Project Name & Address
VOLKSWAGEN HATFIELD
COMET WAY, HATFIELD, AL10 9TF
Building Type
RESIDENTIAL DEVELOPMENT
Drawing Title
AMENDED FLOOR PLANS- FOURTH FLOOR

Drawn By	F.P	Date	03.10.2022
Checked By	F.J	Date	13.10.2022
Approved By	R.V	Date	14.10.2022
Drawing Number	HAT-RDB-XX-04-DR-A-NMA-0204		
Sheet No.	01	Scale	1:100
Orig. Sheet Size	@A0	Rev.	R01

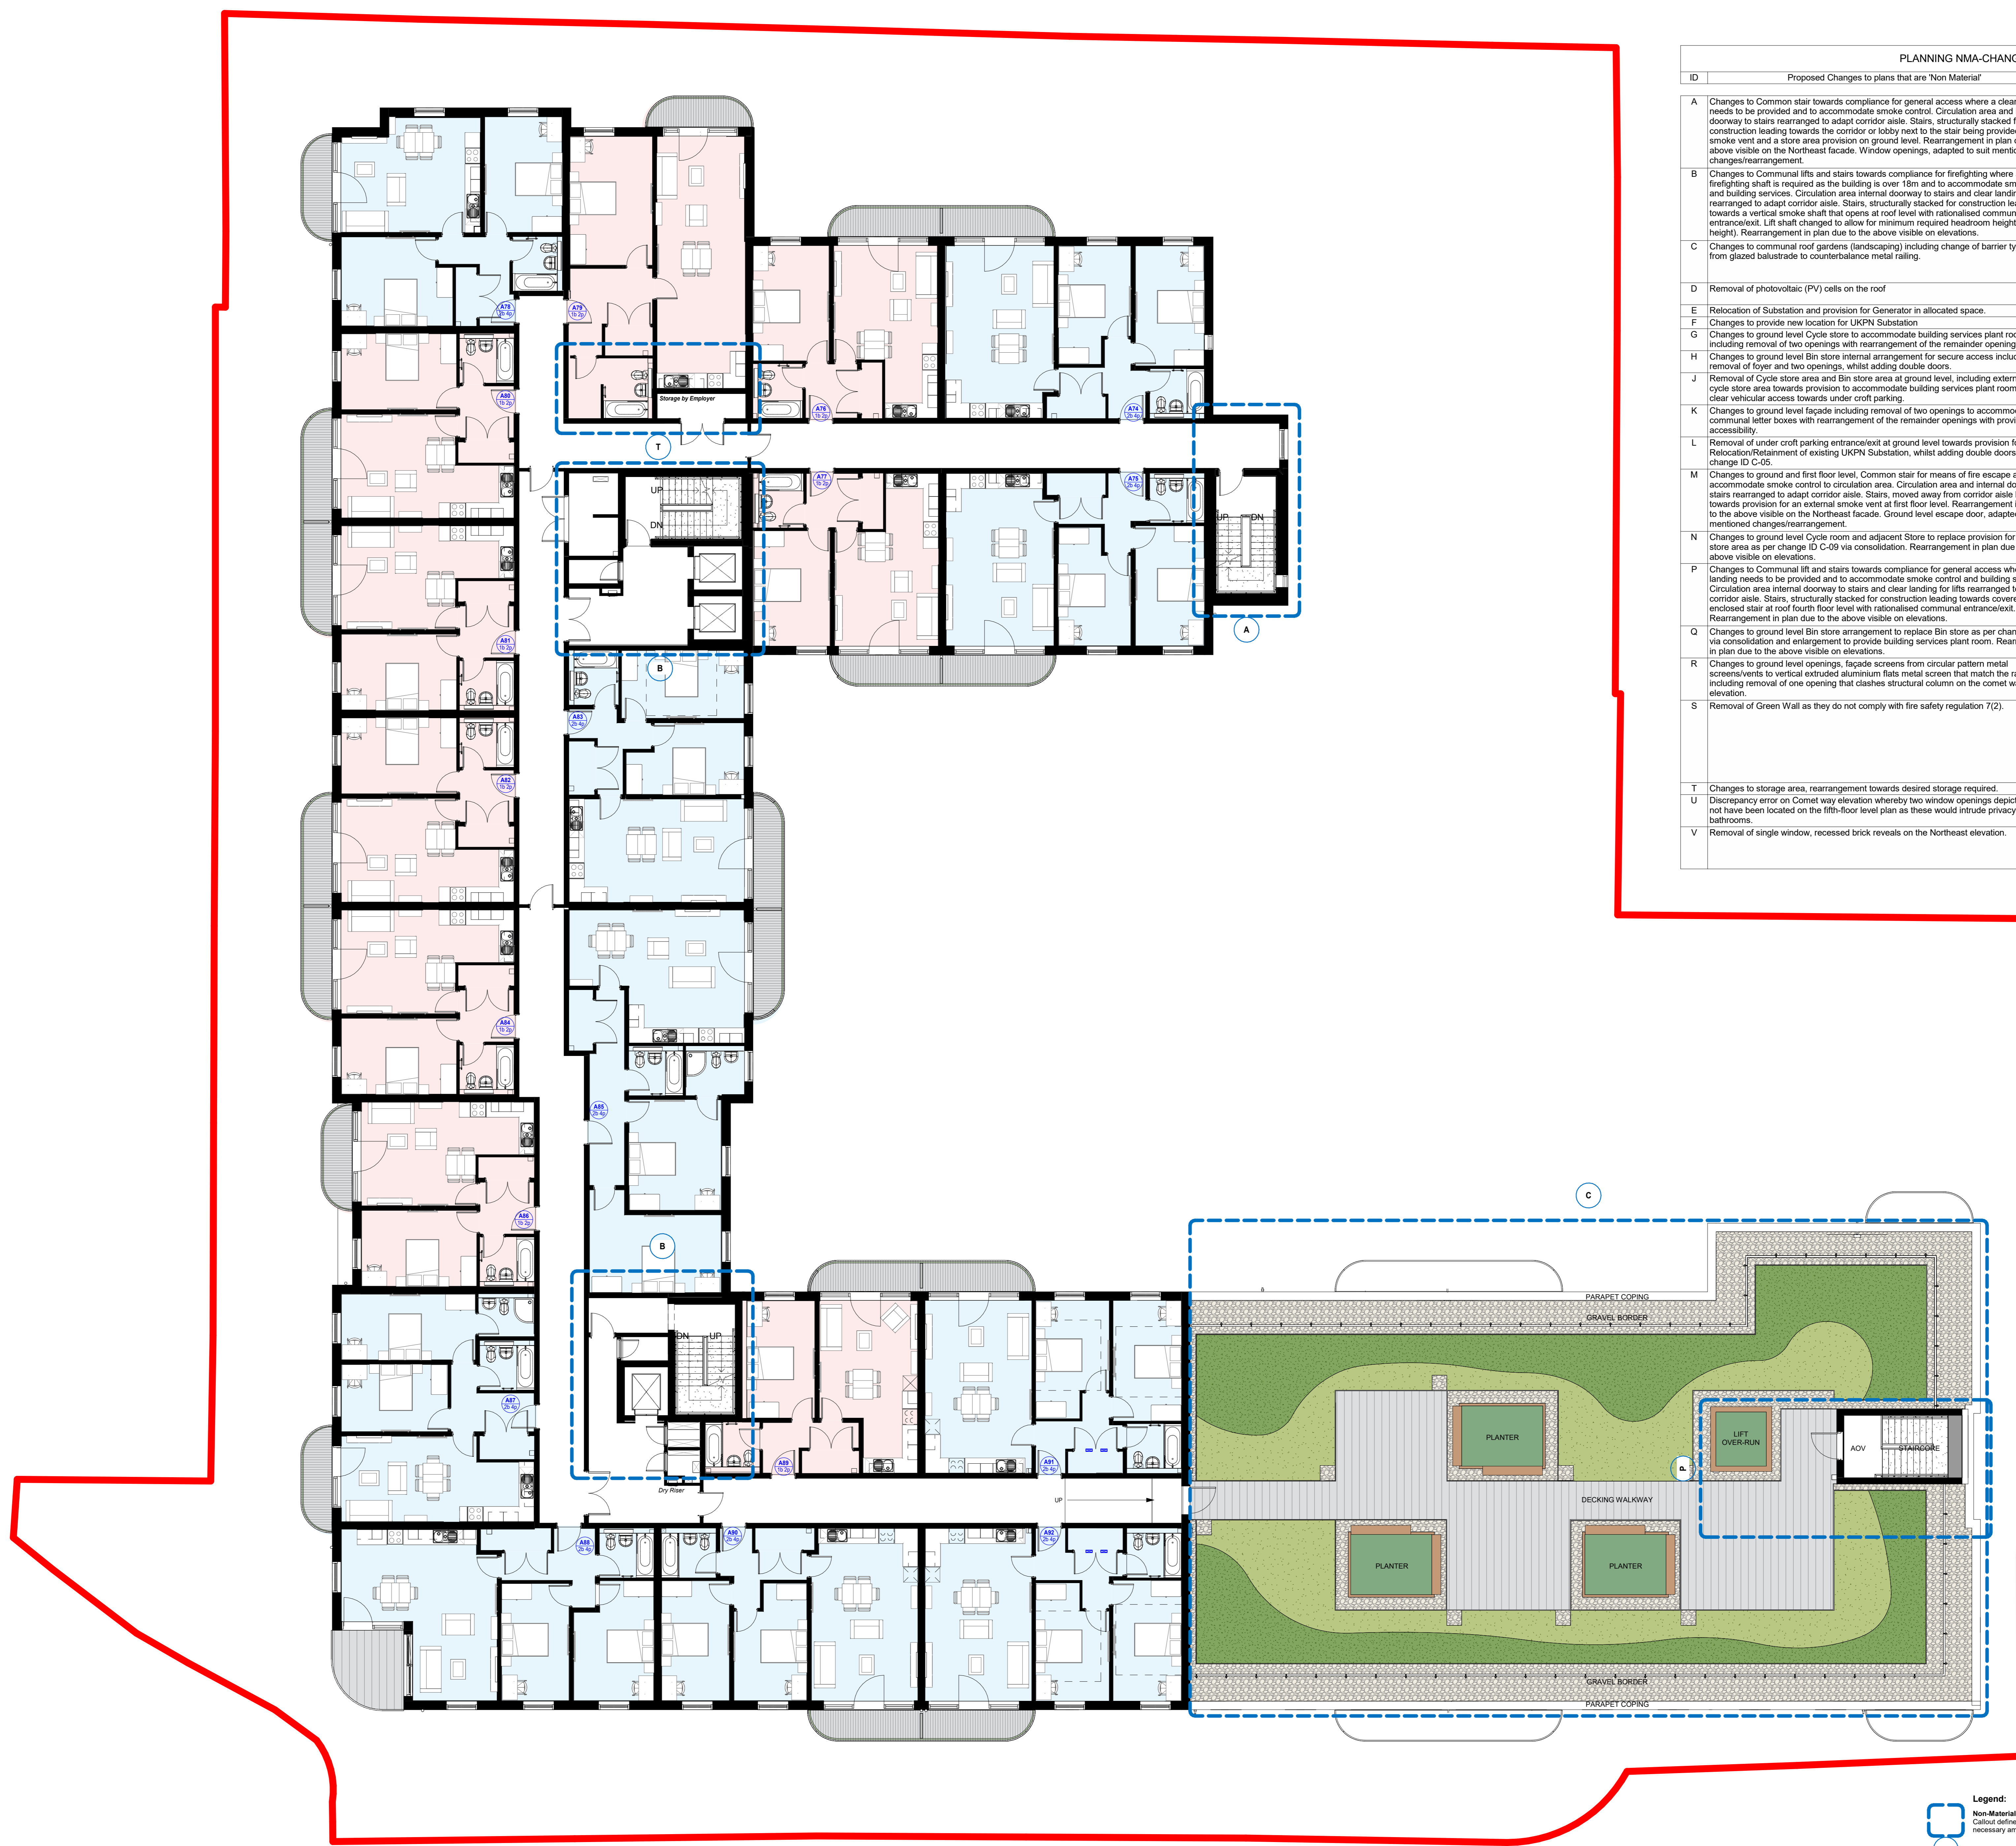
PLANNING NMA-CHANGE LIST		
ID	Proposed Changes to plans that are 'Non Material'	Reason for 'Amendment'
A	Changes to Common stair towards compliance for general access where a clear landing needs to be provided and to accommodate smoke control. Circulation area and internal doorway to stairs rearranged to adapt corridor aisle. Stairs, structurally stacked for construction leading towards the corridor or lobby next to the stair being provided with a smoke vent and a store area provision on ground level. Rearrangement in plan due to the above visible on the Northwest facade. Window openings, adapted to suit mentioned changes/rearrangement.	Compliance towards Building Regulations, Part-K-Protection from falling, collision and impact and Part-B-Fire safety
B	Changes to Communal lifts and stairs towards compliance for firefighting where a firefighting shaft is required as the building is over 18m and to accommodate smoke control and building services. Circulation area internal doorway to stairs and clear landing for lifts rearranged to adapt corridor aisle. Stairs, structurally stacked for construction leading towards a vertical smoke shaft that opens at roof level with rationalised communal entrance/exit. Lift shaft changed to allow for minimum required headroom height (Overhead height). Rearrangement in plan due to the above visible on elevations.	Compliance towards Building Regulations, Part-K-Protection from falling, collision and impact, Part-B-Fire safety, and Provision for minimum required headroom height as per standards EN81-20

C	Changes to communal roof gardens (landscaping) including change of barrier type (railing) from glazed balustrade to counterbalance metal railing.	To contribute positively towards biodiversity via balance of soft and hard landscaping schemes including provisions for bird and bat boxes, whilst maintaining overall uniformity for railing type.
D	Removal of photovoltaic (PV) cells on the roof	PV was not required as Part L requirement was met using Exhaust Air Heat Pumps.
E	Relocation of Substation and provision for Generator in allocated space.	Provision for separate secluded area for generator
F	Changes to provide new location for UKPN Substation	Provision for future relocation for UKPN Substation
G	Changes to ground level Cycle store to accommodate building services plant rooms including removal of two openings with rearrangement of the remainder openings.	Provision towards Building Services, Secondary LV switch room and Corms room.

H	Changes to ground level Bin store internal arrangement for secure access including removal of foyer and two openings, whilst adding double doors.	Provision towards secure access for Bin store
J	Removal of Cycle store area and Bin store area at ground level, including external door in cycle store area towards provision to accommodate building services plant room including clear vehicular access towards undercroft parking.	Provision towards Building Services, Primary LV switch room and vehicular access towards undercroft parking.
K	Changes to ground level facade including removal of two openings to accommodate communal letter boxes with rearrangement of the remainder openings with provision for accessibility.	Provision towards communal letter boxes
L	Removal of undercroft parking entrance/exit at ground level towards provision for Relocation/Retainment of existing UKPN Substation, whilst adding double doors as per change ID C-05.	Provision towards single point of entry/exit for undercroft parking and towards relocation/retainment of existing UKPN Substation mentioned in change ID-E.

M	Changes to ground and first floor level, Common stair for means of fire escape and to accommodate smoke control to circulation area. Circulation area and internal doorway to stairs rearranged to adapt corridor aisle. Stairs, moved away from corridor aisle leading towards provision for an external smoke vent at first floor level. Rearrangement in plan due to the above visible on the Northeast facade. Ground level escape door, adapted to suit mentioned changes/rearrangement.	Compliance towards Building Regulations, Part-B-Fire safety.
N	Changes to ground level Cycle room and adjacent Store to replace provision for Cycle store area as per change ID C-09 via consolidation. Rearrangement in plan due to the above visible on elevations.	Provision towards replacement of removed cycle store mentioned in change ID-J.
P	Changes to Communal lift and stairs towards compliance for general access where a clear landing needs to be provided and to accommodate smoke control and building services. Circulation area internal doorway to stairs and clear landing for lifts rearranged to adapt corridor aisle. Stairs, structurally stacked for construction leading towards covered and enclosed stair at roof fourth floor level with rationalised communal entrance/exit. Rearrangement in plan due to the above visible on elevations.	Compliance towards Building Regulations, Part-K-Protection from falling, collision and impact, Part-B-Fire safety and Provision for stair enclosed/walkway that is directly covered.

Q	Changes to ground level Bin store arrangement to replace Bin store as per change ID C-09 via consolidation and enlargement to provide building services plant room. Rearrangement in plan due to the above visible on elevations.	Provision towards replacement of removed Bin store mentioned in change ID-J and provision for BCW Tank room.
R	Changes to ground level openings, facade screens from circular pattern metal screens/vents to vertical extruded aluminium flats metal screen that match the railing type, including removal of one opening that clashes structural column on the comet way elevation.	To maintaining overall architectural uniformity and structural framing.
S	Removal of Green Wall as they do not comply with fire safety regulation 7(2).	Regulation 7(2), requires all residential blocks with top storey heights over 18m to have all materials which become part of an external wall or specified attachment (e.g., balconies) to achieve class A2-s1, d0 or class A1, except for materials which are exempt as per regulation 7(3). Additionally, membranes used as part of external wall construction above ground should achieve a minimum of class B-s3, d0.

T	Changes to storage area, rearrangement towards desired storage required.	Provision towards desired storage required.
U	Discrepancy error on Comet way elevation whereby two window openings depicted would not have been located on the fifth-floor level plan as these would intrude privacy for the bedrooms.	Discrepancy error
V	Removal of single window, recessed brick reveals on the Northeast elevation.	The recessed brick reveals is between two windows mostly on all elevations, whilst single windows mostly do not have such a detail. To maintain architectural uniformity, detail removed.
